Addendum No. 2
Frederick County Detention Center Commissioner's Office Bullet Resistant Glass Wall
K22-0091-79

06/06/2022

C1. Add: Attachment 2, Hand Drawings

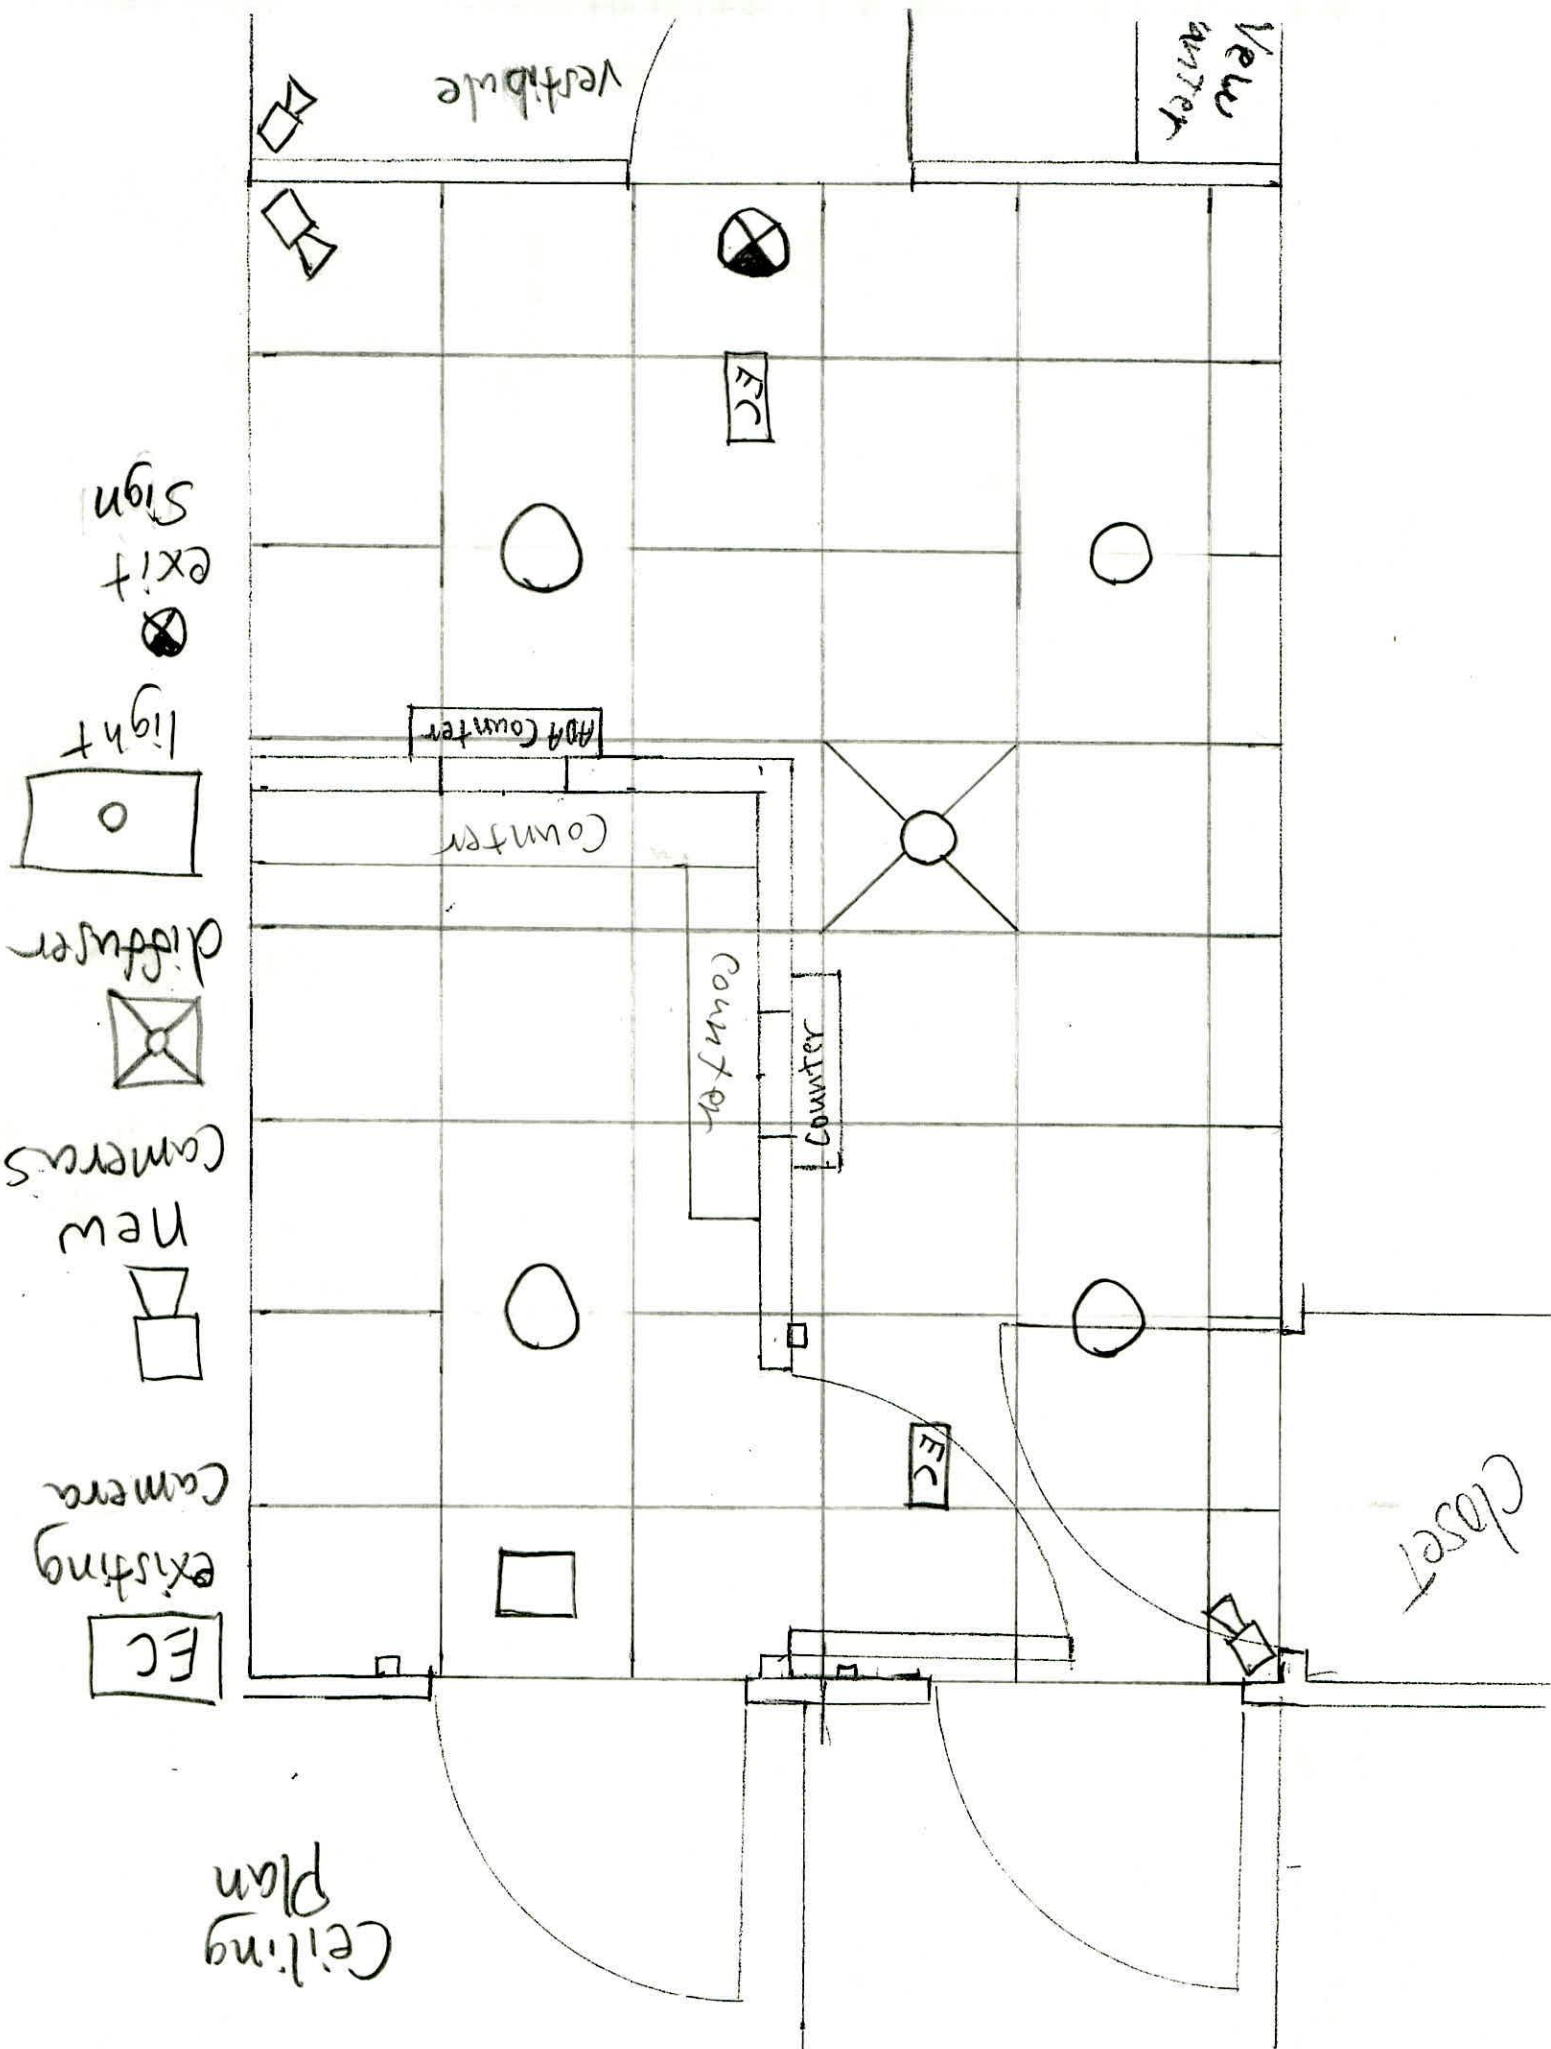
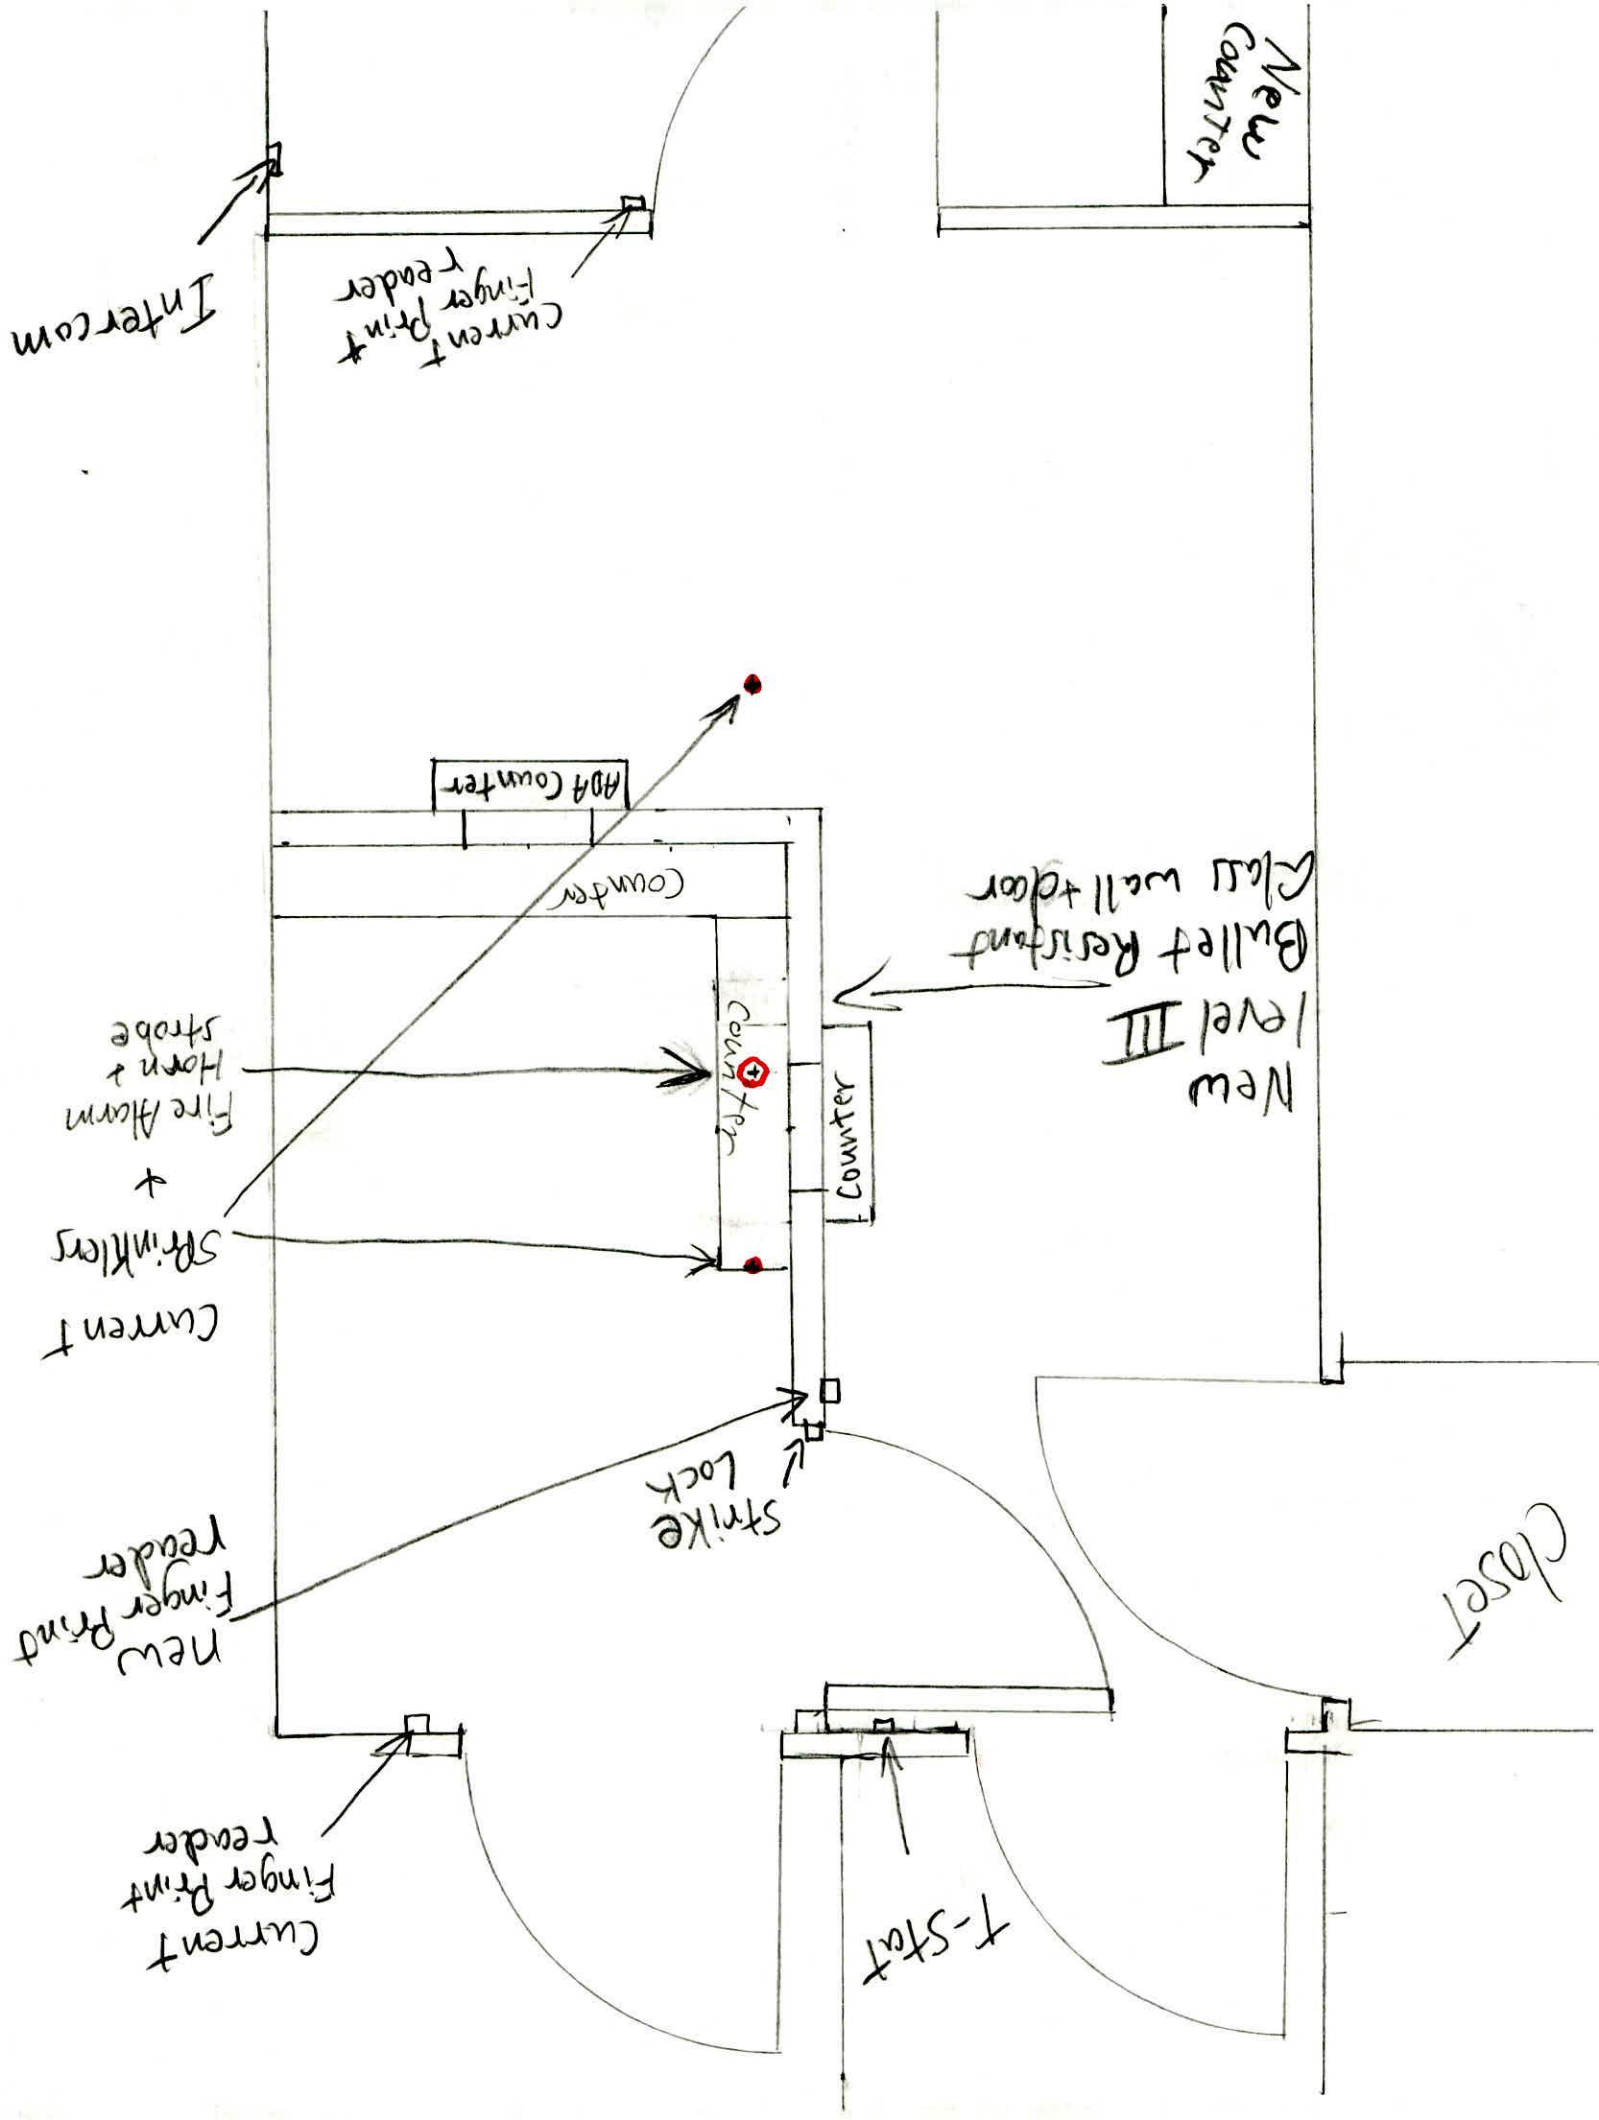
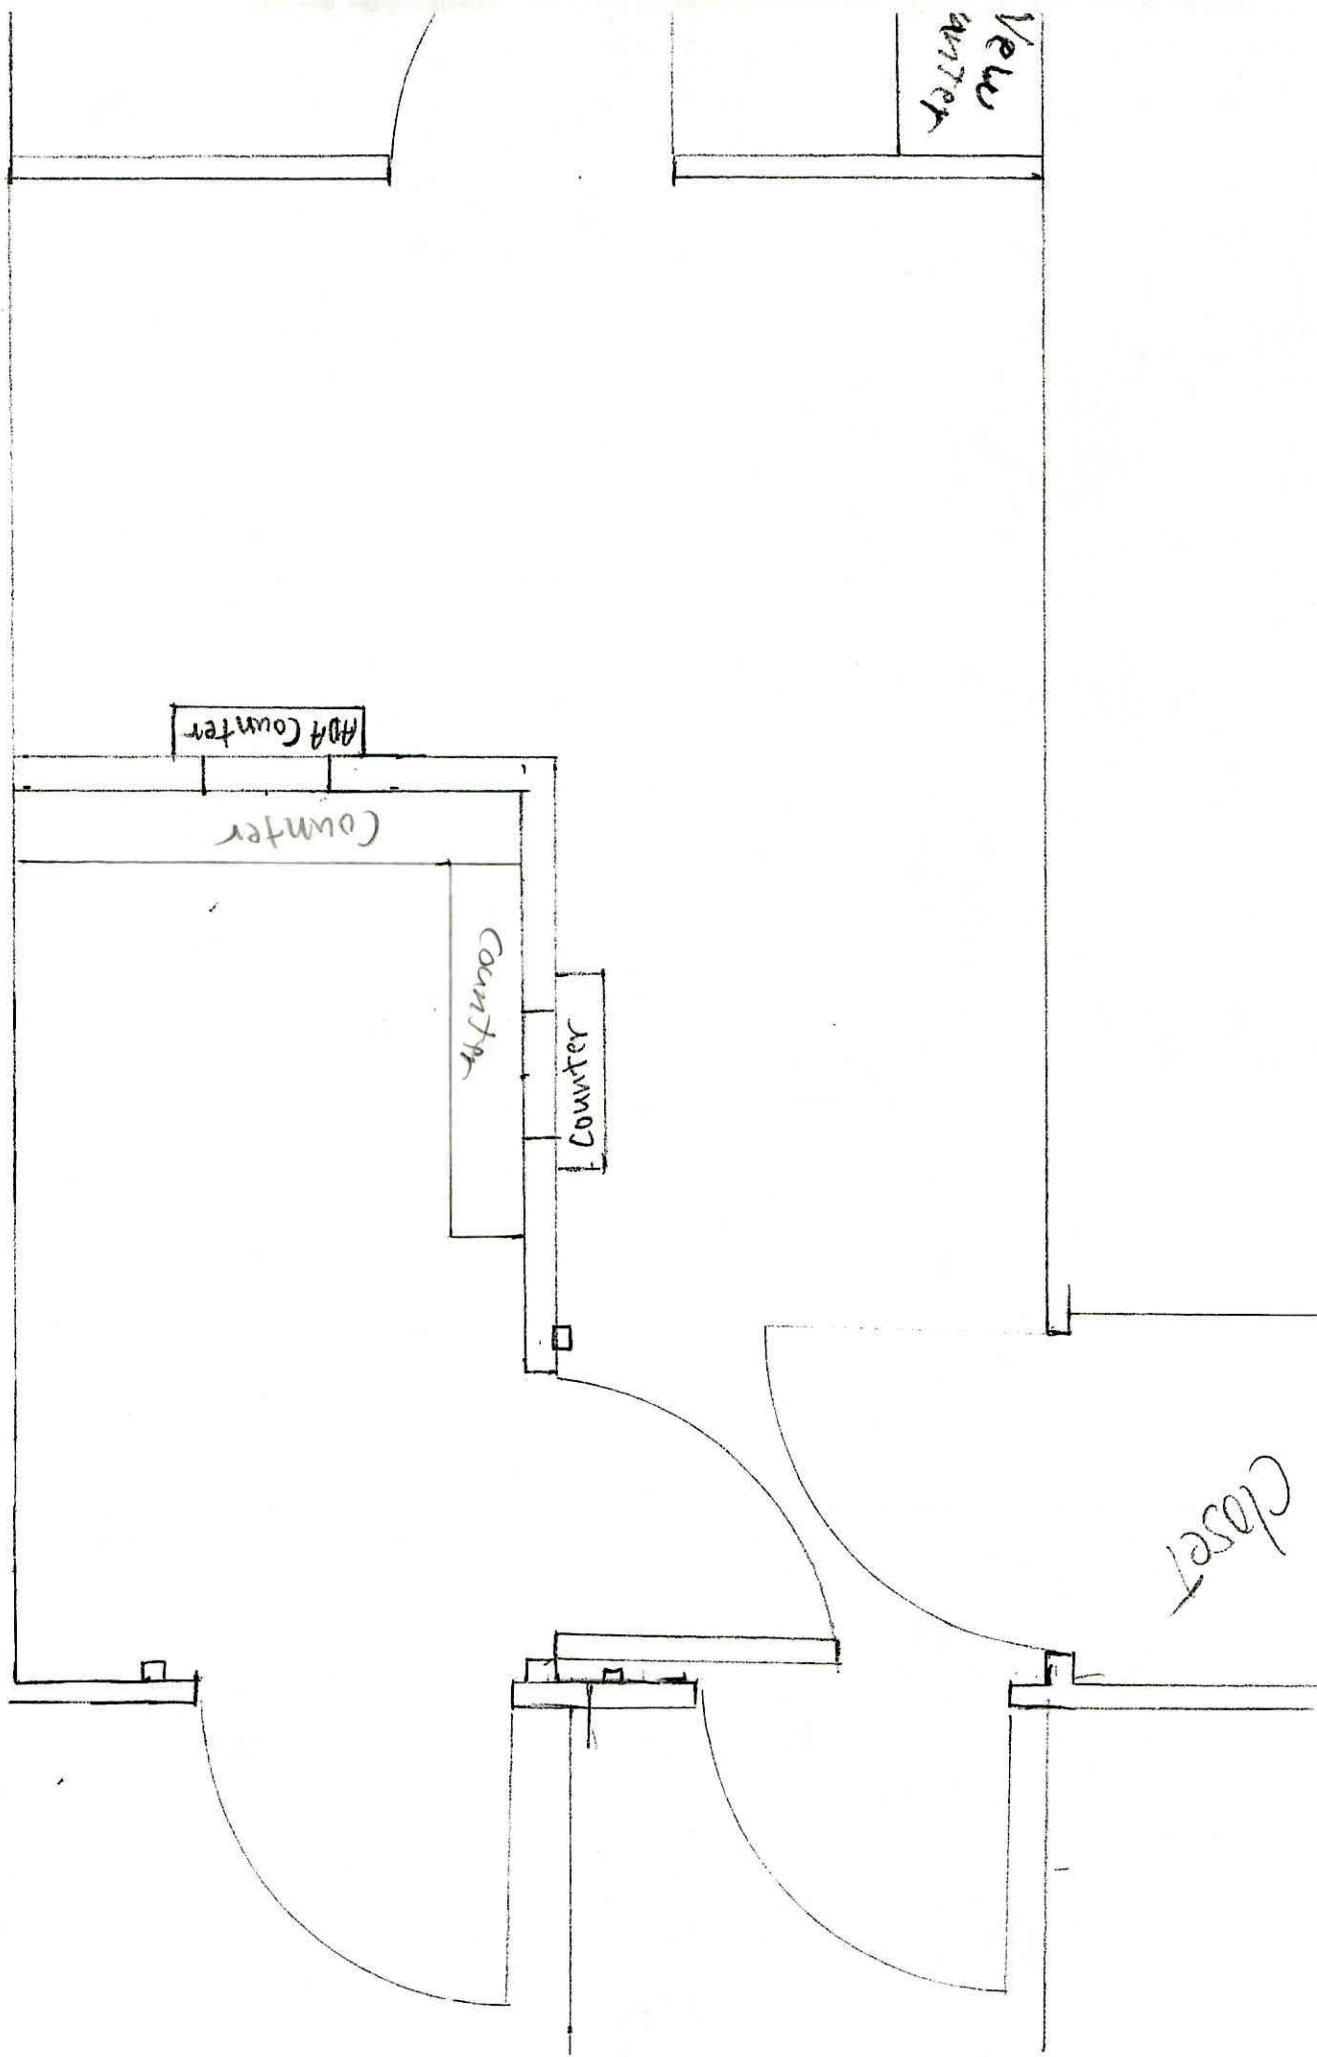
Q5. Please provide an elevation sketch to show how the counter, glass, and walls are expected to look.

Q7. Please confirm whether Level 3 bullet resistant wall panels will be required around the bullet resistant glass. If yes, confirm where the wall panels should go.

Q5. Refer to Attachment 2 attached in this addendum.

A7. Panels are not required around the glass and panels. Please refer to Attachment 2 for the placement of the glass and panels.
